PLANNING AND ZONING BOARD STAFF REPORT

The Maxwell

Meeting	File No.	Application Type
August 12, 2024	2023-196-SPF-SPR-CL5	Architectural Style
Property Owner	Applicant	Agent
306 NE 2 nd Street LLC	Harold Van Armem	Jon Kinsman

Provide a recommendation to the City Commission regarding the implementation of the Art Deco architectural style within the Central Business District (CBD), for a mixed-use development at 306 NE 2nd Street

Proposed Design:

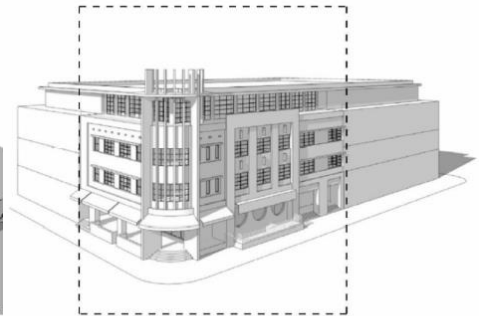
Art Deco is a distinguished architectural style celebrated for its opulence, geometric intricacies, and vivid color palette. The design incorporates geometric shapes and notable articulation between solid and void, particularly on the first three stories of the north elevation.

The custom ornamental cladding on the north elevation has the potential to be the centerpiece of the design, particularly in its interaction with the civic space. The cantilevered eyebrow along with vertical articulation of windows are in harmony. However, the design lacks vertical elements linking the four stories together; the asymmetric windows and the mismatch of horizontal elements disconnect this portion of the building with the rest of the design.

ART DECO - COMPOSITION

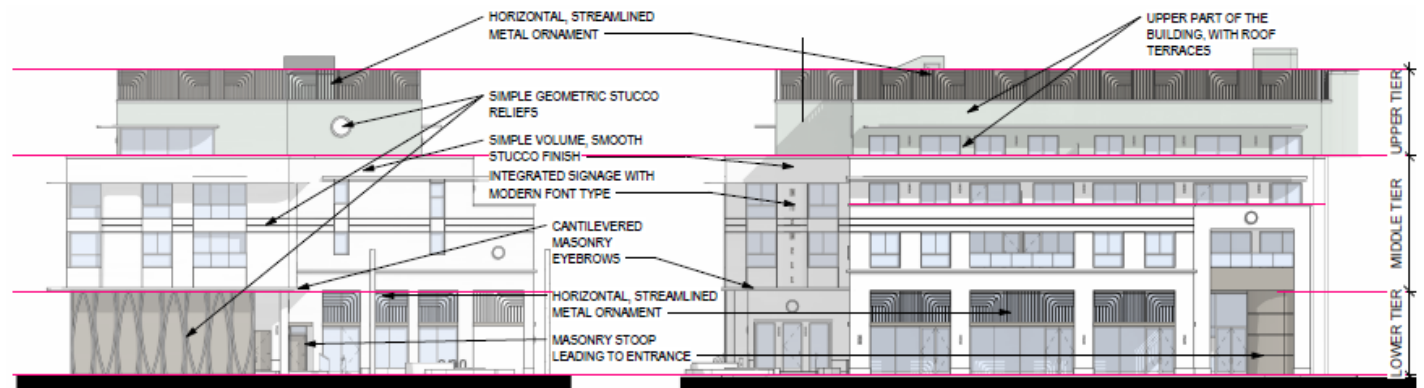
A successful Art Deco facade often consists of distinct sections—base, middle, and top—each with its own decorative treatment. The proposed design aspires to capture the grandeur of Art Deco, and its adherence to the style is evident. The proposed tripartite facades mass, with its clear division into base, middle, and top sections, provides a strong foundation and a sense of rhythmic progression.

EAST ELEVATION - STYLE

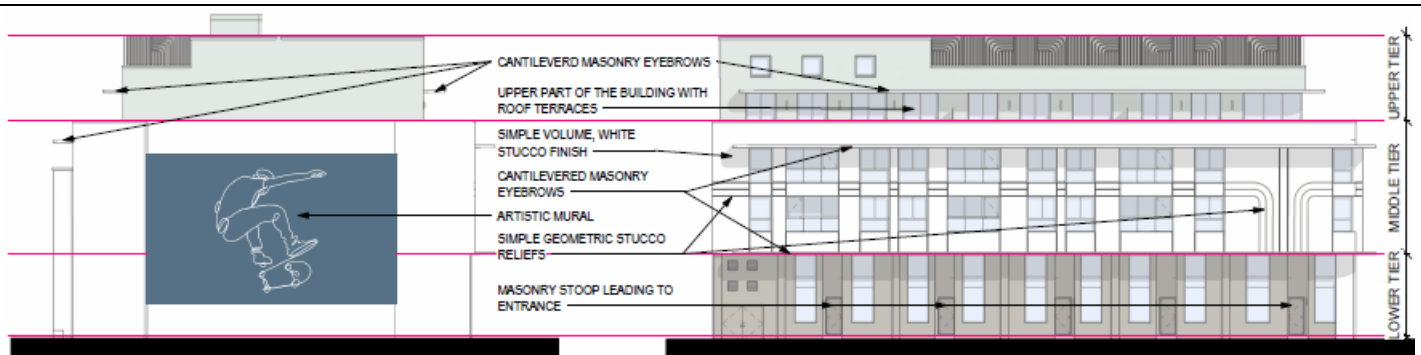
The design's approach to openings is successful in many areas in defining Art Deco architecture, particularly with the vertical articulation of windows on the north elevation. However, the south Elevation lacks the characteristic vertical emphasis, diminishing its authenticity and visual impact. To enhance the Art Deco aesthetic, a more intentional incorporation of vertical articulation and decorative detailing is recommended to achieve a visually cohesive and engaging look. Additionally, it is recommended that the applicant explore the possibility of adding geometric details around the window openings on the south elevation. These details could echo the motifs used in the cladding, further strengthening the visual connection and unifying the design language across different elements.

The choice of stucco finishes, decorative aluminum screen, stucco wall medallion, custom ornamental parapet contributes to a rich and lavish color palette that aligns with Art Deco style. Smooth and sleek surfaces, paired with harmonious material combinations, reflect the luxury associated with Art Deco exteriors.
